PLANNING COMMISSION
DATE: 2/23/14
AGENDA ITEM: 4C – PUBLIC HEARING
CASE # 2015-03

ITEM: Wildflower at Lake Elmo Preliminary Plat and Preliminary PUD Plan

SUBMITTED BY: Kyle Klatt, Community Development Director

PRELIMINARY PLAT

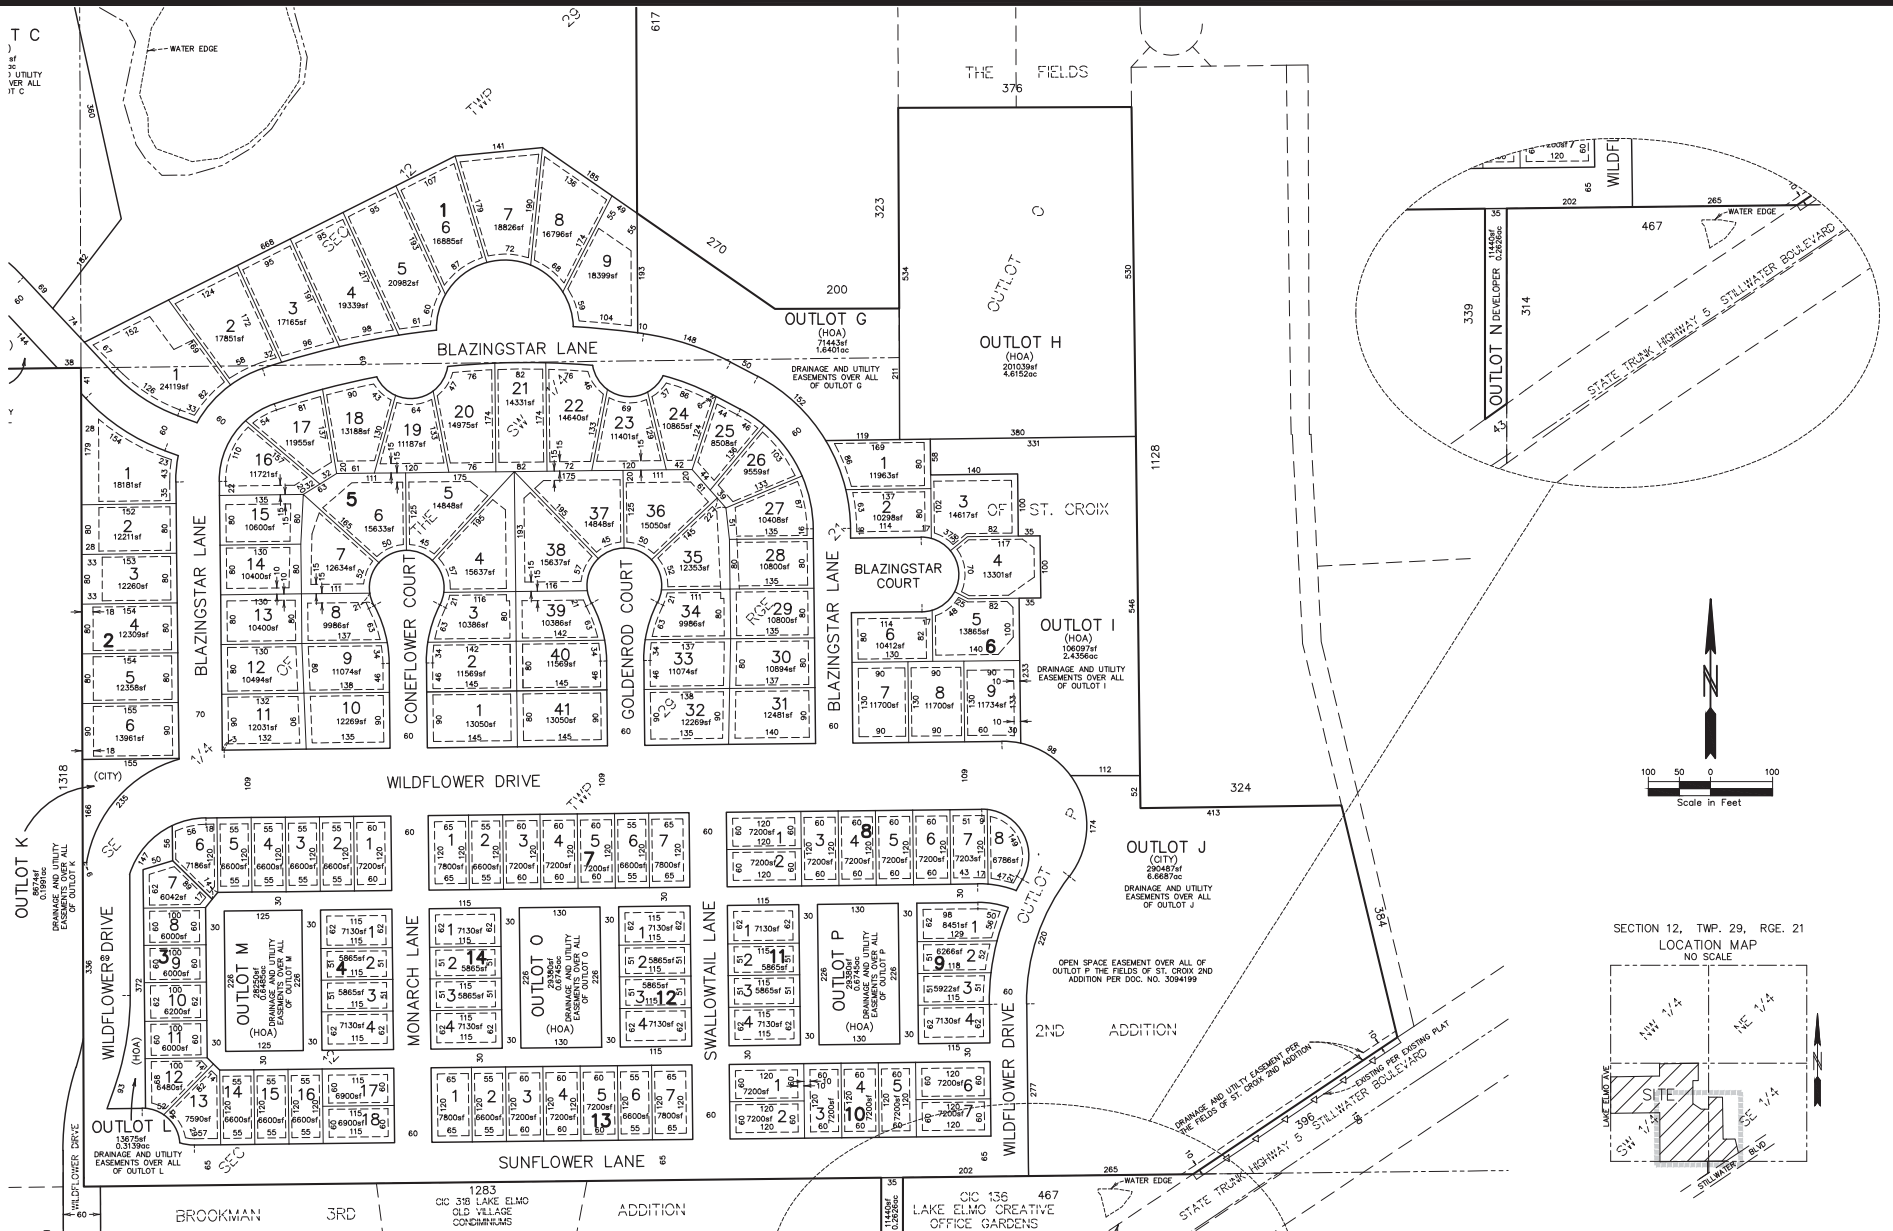
- Wetland buffers should be shown on the Plat (Sheets 6 and 7).
- The Site Plan must be revised to eliminate wetland buffer encroachments as follows to eliminate grading and impervious surfaces:

SITE PLAN

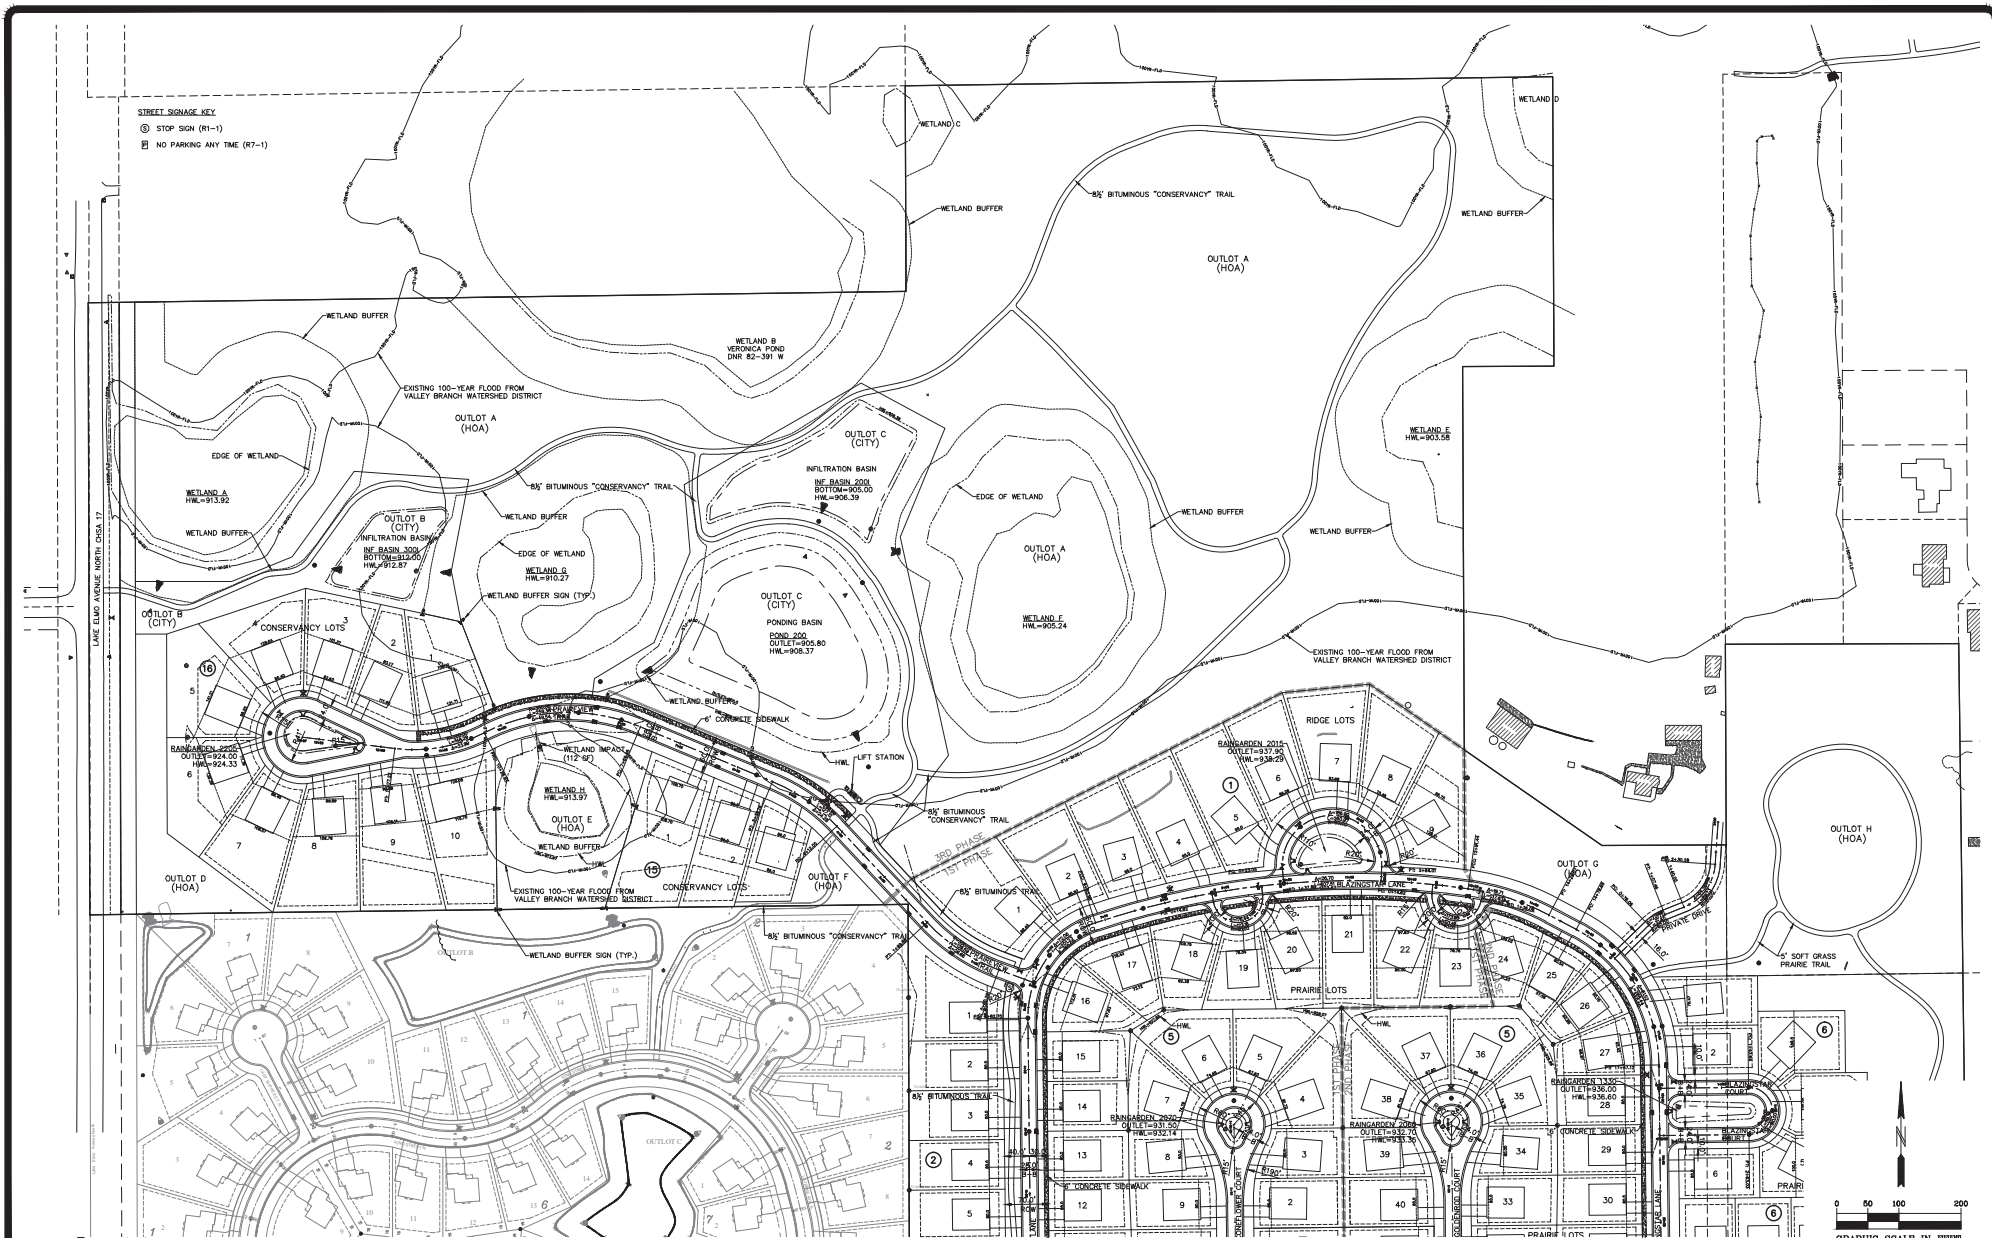
- The Site Plans, Sheets 9 and 10, must be revised using a plan scale of 1 inch = 50 feet to facilitate the review of the street geometrics including horizontal curvature information.

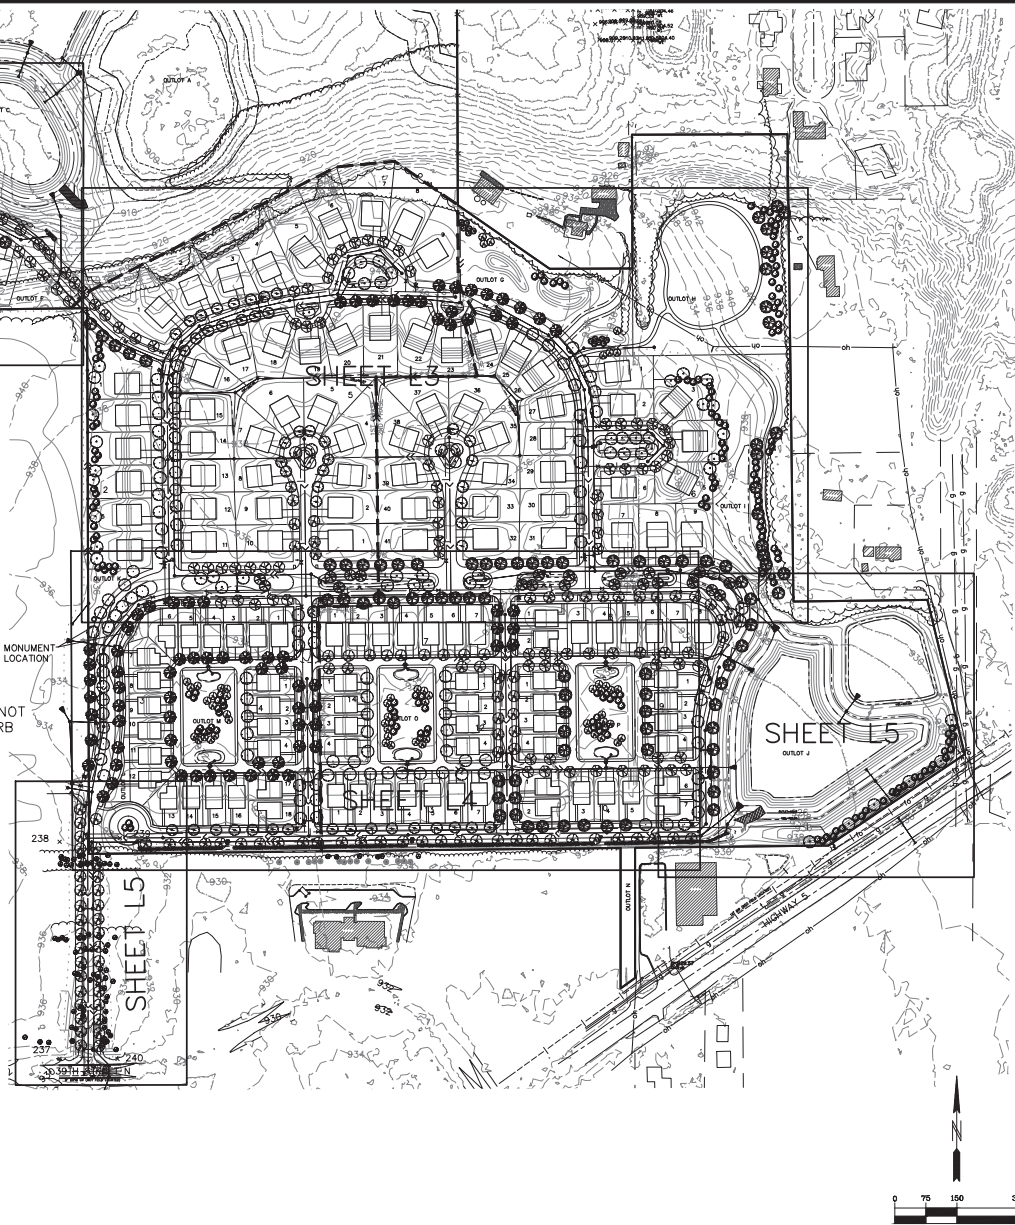
2. Street trees need to be at least 5 feet from back of curb. In areas where the boulevard does not allow this because of sidewalk or trail placement as noted on Sheet L1 please redesign to accommodate required trees.
